RECALL BULLETIN 05V-262 (Rev. A)

DATE: OCTOBER 7, 2005
 MODEL YEAR: 1999 thru Early Production 2002
 CHASSIS MODEL: UD1200/UD1400
 BULLETIN NUMBER: SC-262
 FILE IN THE ELECTRICAL SECTION OF THE TECHNICAL BULLETIN BINDER
 (Discard previous Recall Bulletin dated September 12, 2005)

VOLUNTARY SAFETY RECALL CAMPAIGN NUMBER 05V-262: BATTERY CABLE INSPECTION AND/OR REPLACEMENT

Figure B

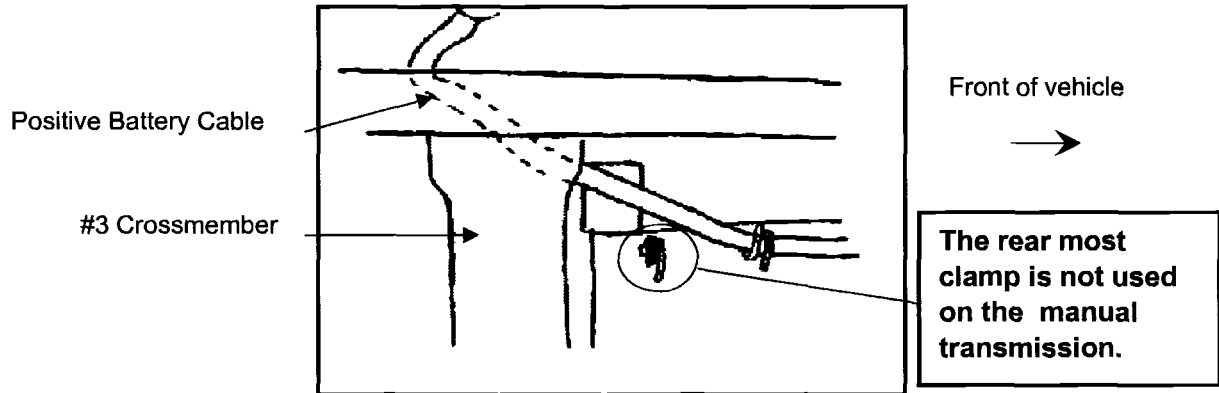
NOTE: Manual Transmission Models: Do not use the rear most retaining clip on the transmission shift cover to secure the battery cable, see Figure B.

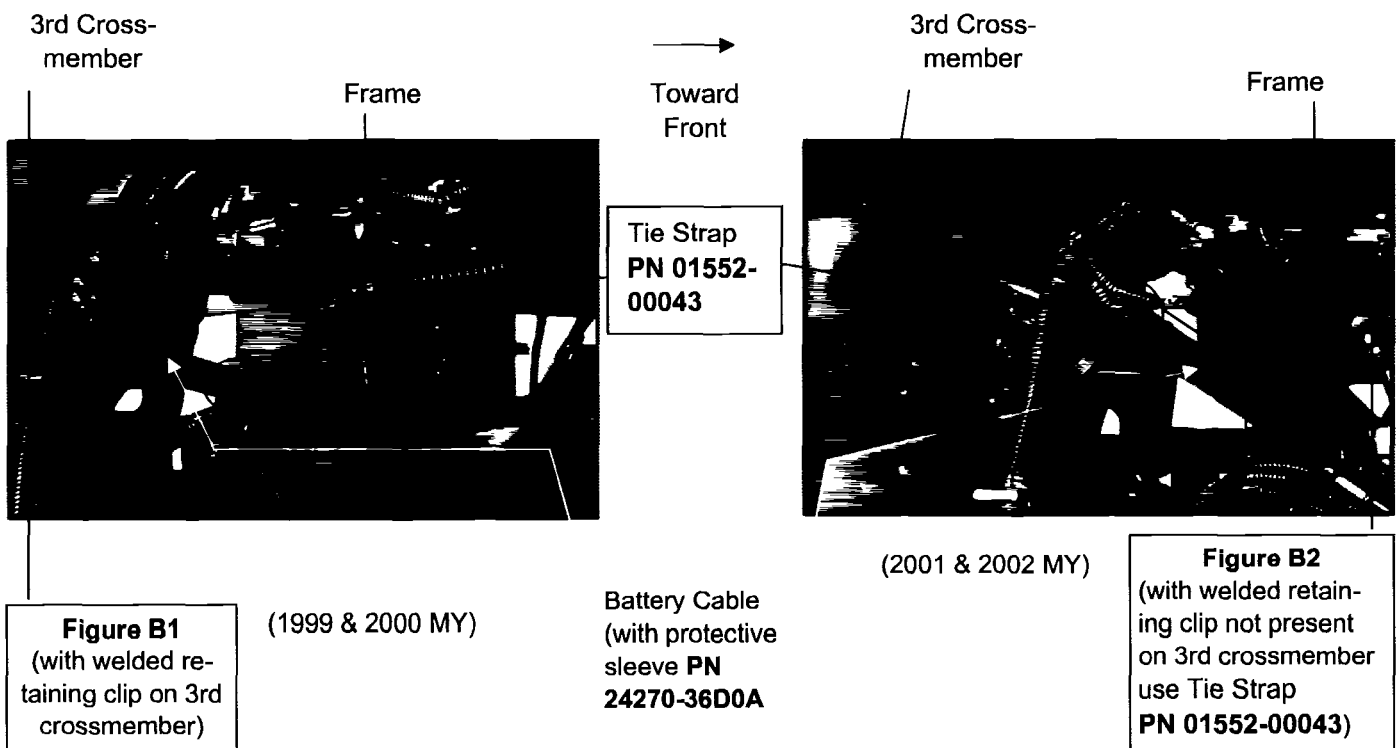
Install the battery cable Protective Sleeve **PN 24270-36D0A** from the Safety Recall **Parts Kit** around the battery cable.

Use 2 Tie Straps **PN 01552-00043** to secure the Protective Sleeve at each end as shown in Figure B1 if the welded retaining clip is present.

Use 2 Tie Straps **PN 01552-00043** to secure the Protective Sleeve at each end and a 3rd tie strap to secure the battery cable to the chassis harness at the crossmember as shown in Figure B2 if the welded retaining clip is not present.
